W-3599 Lillian A Evans & William Luther Dixon (Elm Grove)(Special Use Rezoning from RS9 and RM12-S to RM8-S)

Jurisdiction: City of Winston-Salem
ProjectID: 1106102

Thursday, September 21, 2023

24. Zoning Plan Review

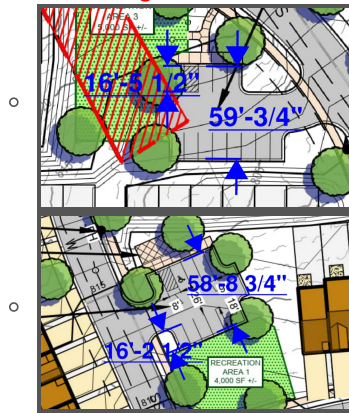
- Your parking spaces for the visitors lot do not meet Dimensional Requirements. It appears you are measuring from the far edge of the curb. The parking diagram shows to measure from the end of the asphalt, not the top/far edge of the curb, likely resulting in some lost feet in both locations. Please review *Table 6.1.3.B: Parking Dimensions* and revise your parking spaces.

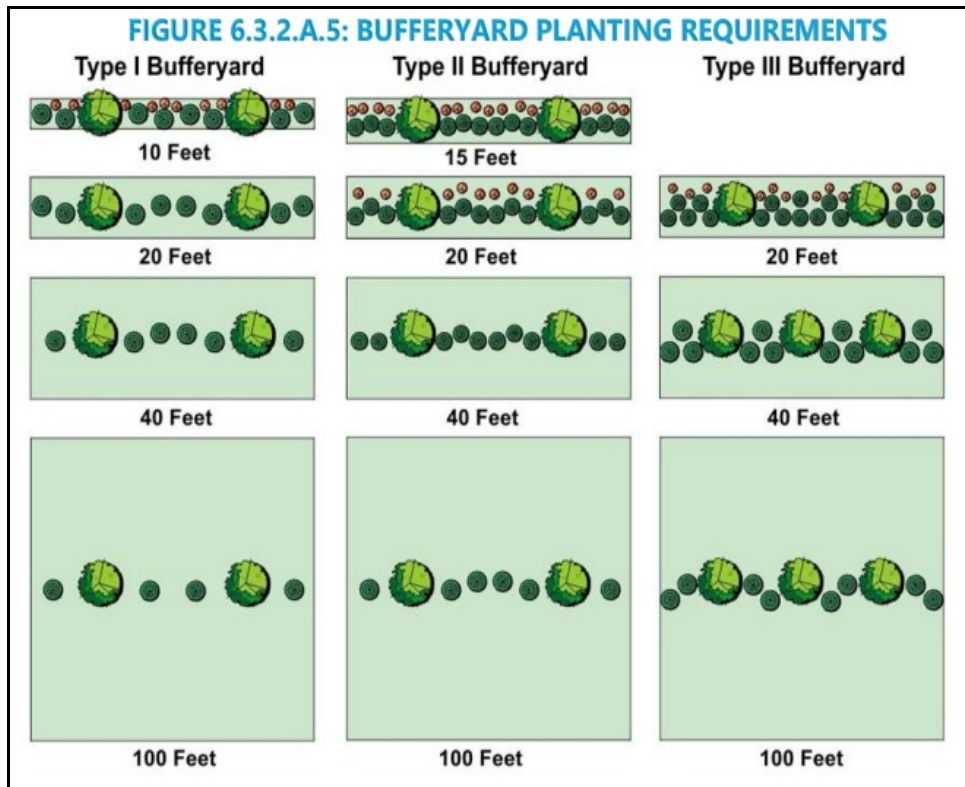
Zoning District	Zoning District Category	Which Property Line?	Adjacent Zoning & category	Bufferyard Type Required
RM8-S	MFR	North	RS9 (Across Public ROW) MU-S	None Type I (Type I Bufferyard required if no bufferyard is provided on developed adjacent property designated as high intensity commercial (HIC) or industrial (IND) zoning types.)
RM8-S	MFR	South	RS9	Type II
RM8-S	MFR	West	RS9	Type II

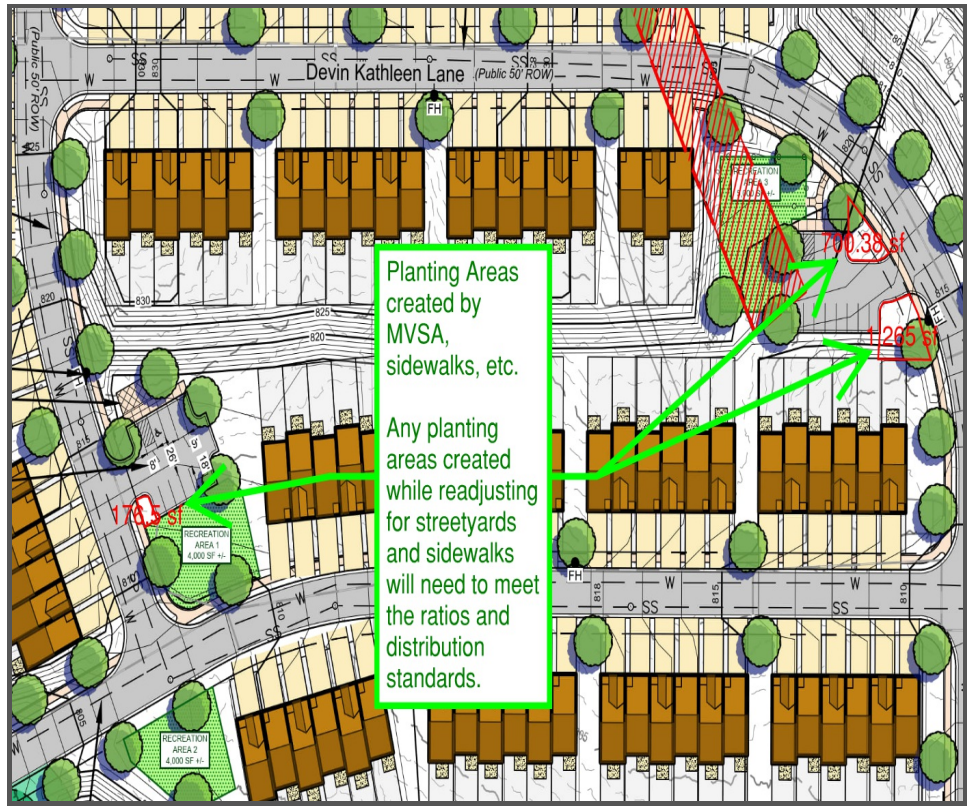
- One large variety tree shall be used for every five thousand (5,000) square feet of MVSA.
 - **The eastern visitors lot has approximately 4,450 sqft of MVSA and the western visitors lot has approximately 3,700 sqft of MVSA. Each parking lot will require 1 large variety tree.**

- **No parking space shall be located more than seventy-five (75) feet from the trunk of a required large variety tree**
- When parking spaces exceed the maximum allowance listed in Table 6.1.2A., Motor Vehicle and Bicycle Parking Space Requirements, supplemental landscaping shall be provided so that no parking space shall be more than fifty (50) feet from the trunk of a required large variety tree located within a minimum planting area of six hundred (600) square feet.
